ARCHITECTURAL REVIEW BOARD STAFF REPORT

Project #/Name	ARB-2025-18: Carter Machinery Major Amendment
Review Type	Second Review of a Major Amendment
Parcel Identification	06100-00-00-12000
Location	721 Rio Road W
Zoned	Highway Commercial (HC) / Entrance Corridor (EC) / Airport Impact Area (AIA)
Owner/Applicant	Mount Sinai Properties-Charlottesville, LLC / Balzer and Associates (Lindsey Buyer)
Magisterial District	Rio
Proposal	To create a rental facility for construction equipment and machinery, including an outdoor storage area and necessary site improvements, on approximately 4.37 acres. To accommodate the proposed outdoor storage area, certain portions of the existing building on the property will be demolished.
Context	The property contains a warehouse consisting of multiple structures at the front of the parcel with paving surrounding it. To the north is Rio Rd. W and commercial development, to the east are several commercial properties, and to the west is the Northside Library. (Fig. 1.)

ARB Meeting Date	December 1, 2025
Staff Contact	Khrist Taggart

Figure 3: Approved Concept Plan and Security Fencing Example.

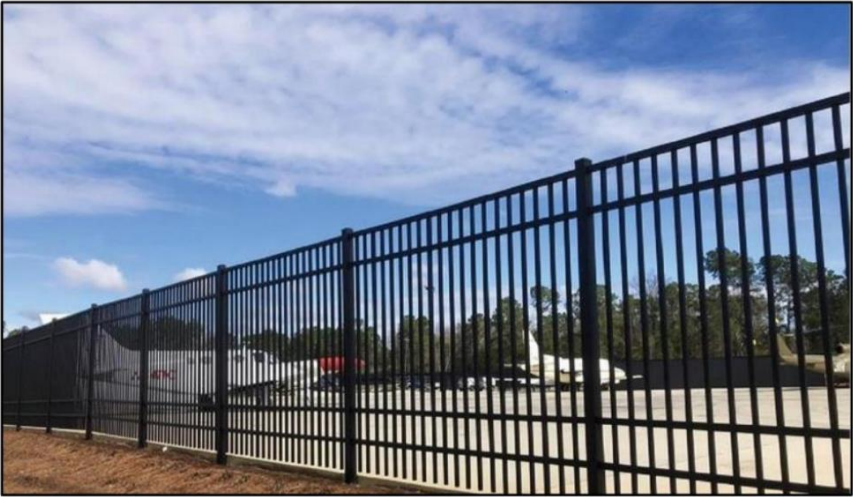
natural vegetation and may consist of: a. Walls, b. Plantings, and c. Fencing.	3). However, the site plan labels all proposed fencing as chain link fencing. The fencing along the northern section of the storage area is expected to be partially visible from the EC through the proposed evergreen screening until it matures fully. Additionally, the gate on the western side will likely be visible from the EC at a distance, so neither section of fencing cannot be made of chain link. The plan will also need to be updated to provide a detail of the proposed security fencing. The site plan shows a dumpster enclosure near the central portion of the eastern property line. In this location, the enclosure may be partially visible from the Rio Rd. EC. The dumpster enclosure detail notes that the enclosure will be constructed from CMU blocks. The distance (approximately 355') and frontage landscaping will likely mitigate the visibility of the enclosure from the EC but revising the site plan to note that the CMU block will match the existing building would fully integrate it into the site.	CMU blocks will match the brick of the building.	existing red brick on the building's façade.

7. Revise the site plan to note a neutral color for the security fencing.
8. Revise the site plan to note the specific block color proposed for the dumpster enclosure.

Figure 4: North, East, and West Elevations September 2, 2025 (above) and December 1, 2025 (below).

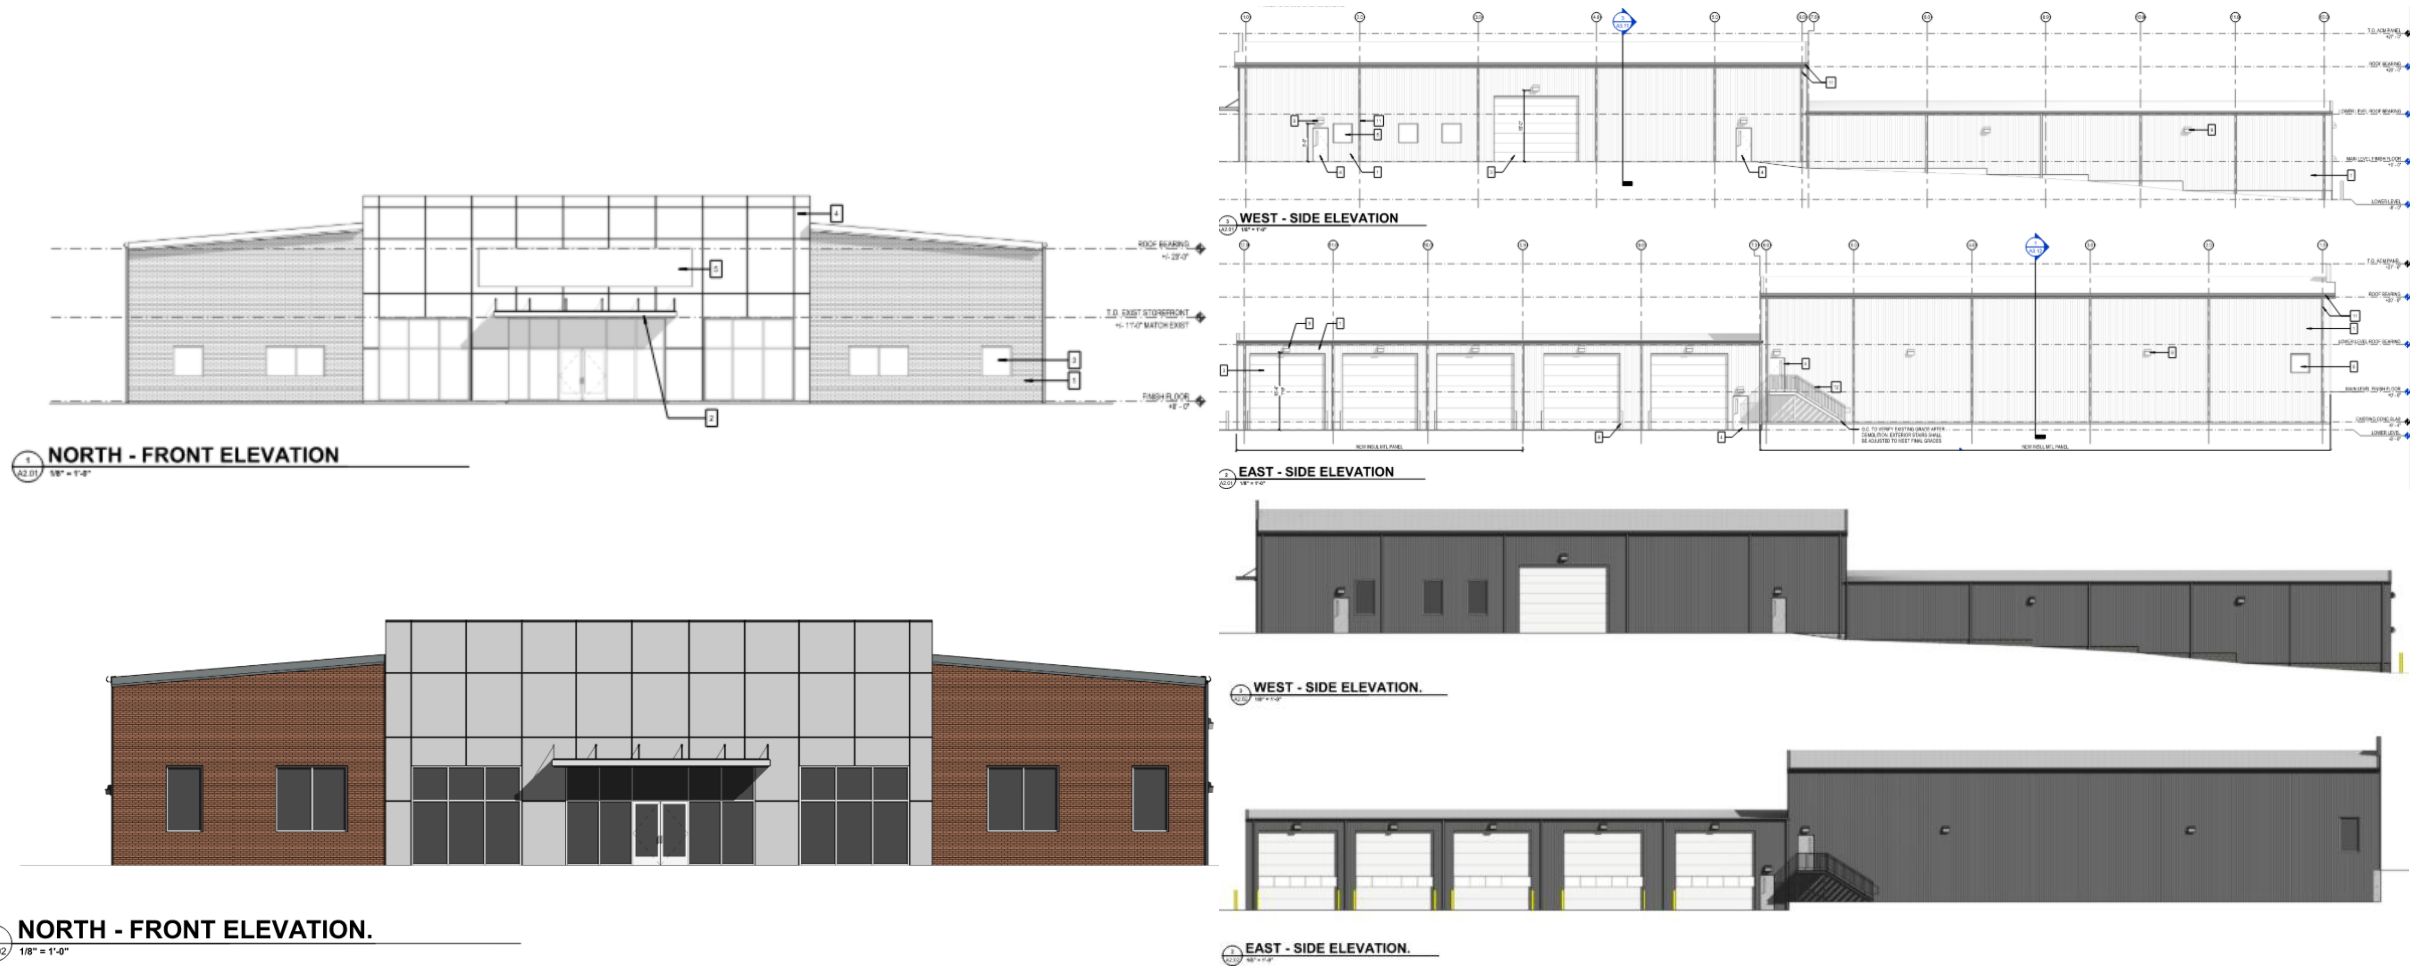
buildings in the area, as well as drawings of architectural features, which provide important examples of this tradition are contained in Appendix A.	sufficiently coordinated with the remaining building. The different roof shapes, the points where the structure meets the existing roof overhang, and the proportions of the new windows in the brick wall could all be better coordinated.		The drawings have been revised to indicate the finish of the proposed ACM panels (Mica Anodic Clear); however, material samples have not been provided to verify their compatibility with the existing building and surrounding context.	
4	The examples contained in Appendix A should be used as a guide for building design: the standard of compatibility with the area's historic structures is not intended to impose a rigid design solution for new development. Replication of the design of the important historic sites in the area is neither intended nor desired. The Guideline's standard of compatibility can be met through building scale, materials, and forms which may be embodied in architecture which is contemporary as well as traditional. The Guidelines allow individuality in design to accommodate varying tastes as well as special functional requirements.	The ACM panels may be compatible with the contemporary architectural elements present in the Northside Library building design, which is located on the adjacent parcel to the west; however, specific details regarding the texture and finish of the panels have not been provided. This information will be needed to determine the level of compatibility of the new structure with both the existing building and the surrounding context. It is important to note that panel finishes that exhibit excessive reflectivity would not be suitable for the EC.		The side elevations and details of the proposed changes to these elevations have been added to the architectural drawings. On the east elevation, the drawings show new metal panels in the areas where infill is needed due to the demolition of existing building additions. However, no details have been provided regarding the areas in need of maintenance along the west elevation.

1. The design and compatibility of the tower element with the existing building.
2. The appearance of the east and west elevations.

1. Revise the line drawings to match the changes shown in the renderings.
2. Provide material samples with the next submittal.
3. Revise the architectural drawings to identify the areas in need of maintenance along the west elevation and to note how they will be repaired.
